UNITED STATES
NUCLEAR REGULATORY COMMISSION
WASHINGTON, D. C. 20555

WESTINGHOUSE ATWS CATEGORY B - LOSS OF NORMAL AC POWER

WESTINGHOUSE ATWS
LOSS OF NORMAL AC POWER

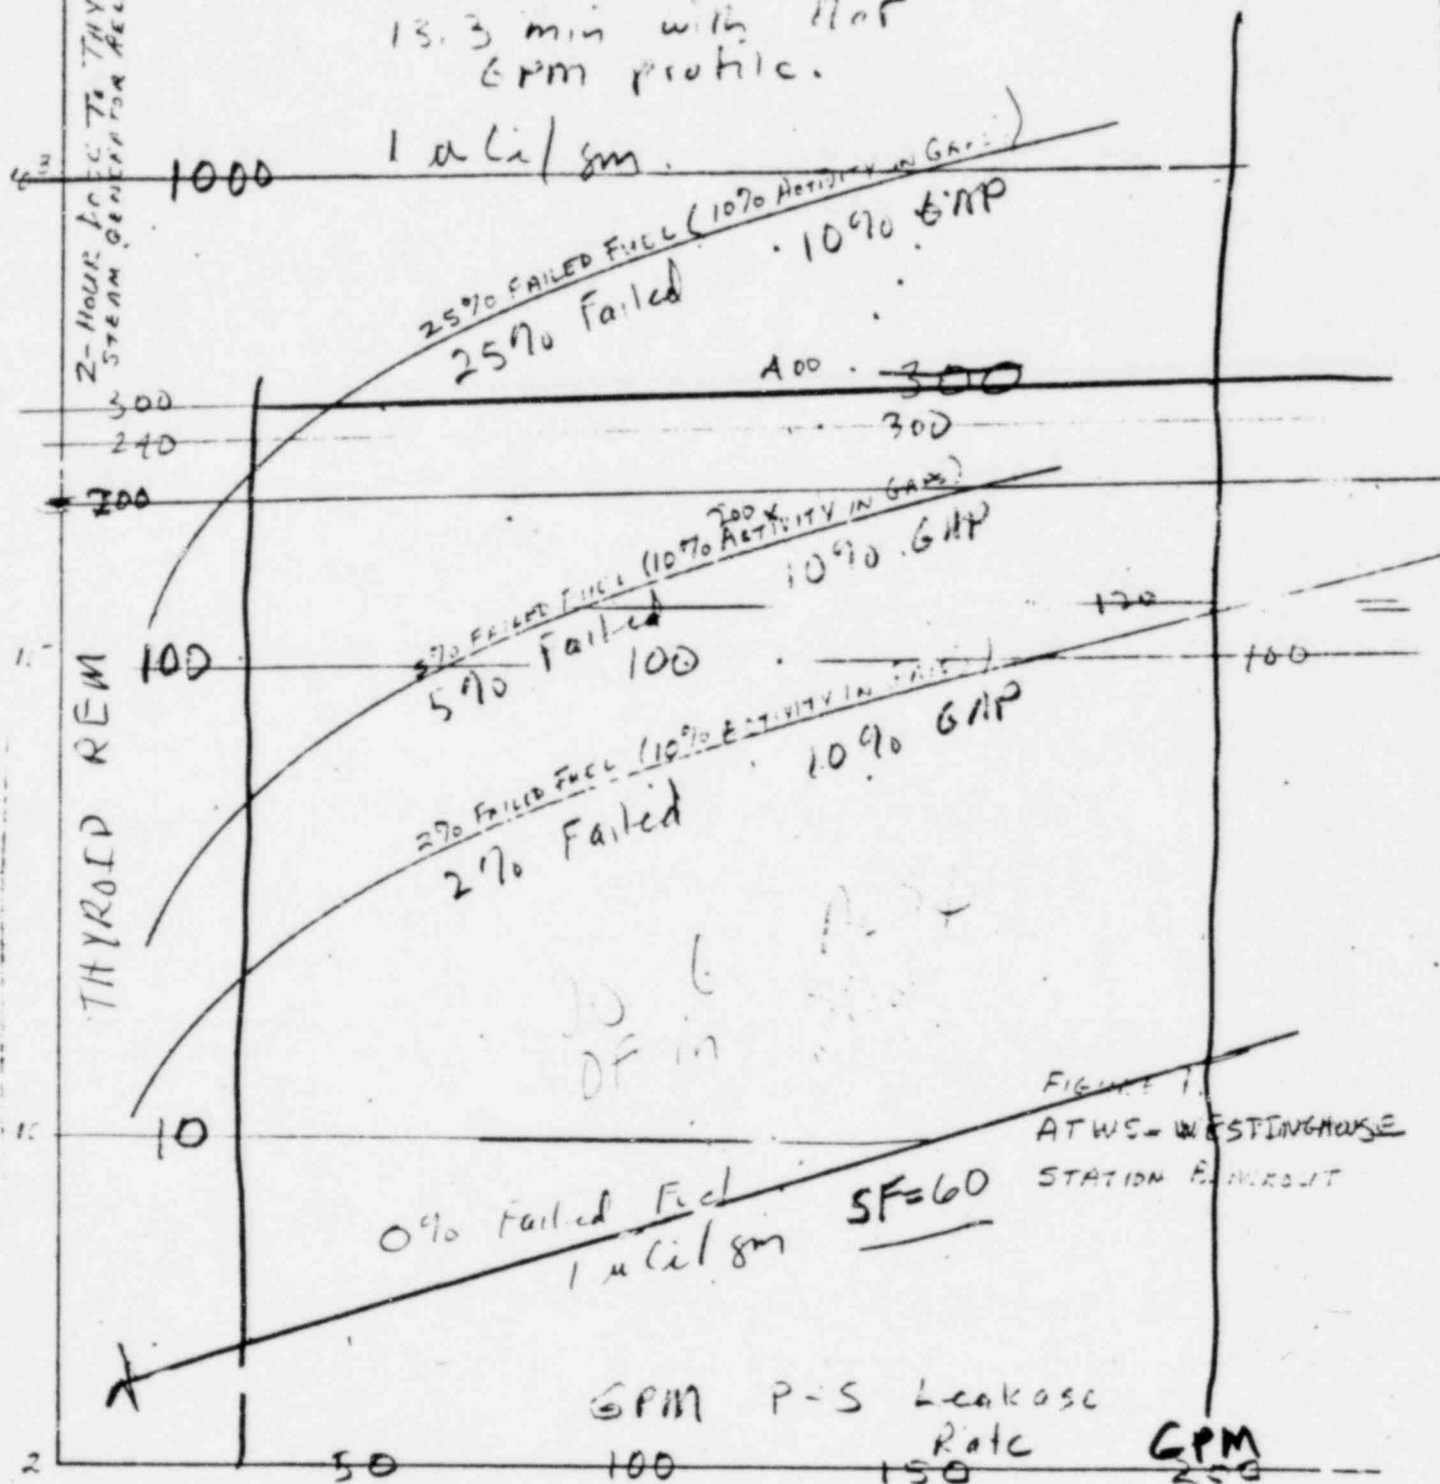
Release Interval
(100% Primary Release)

13.3 min with flat
6mm profile.

1 a li / gm.
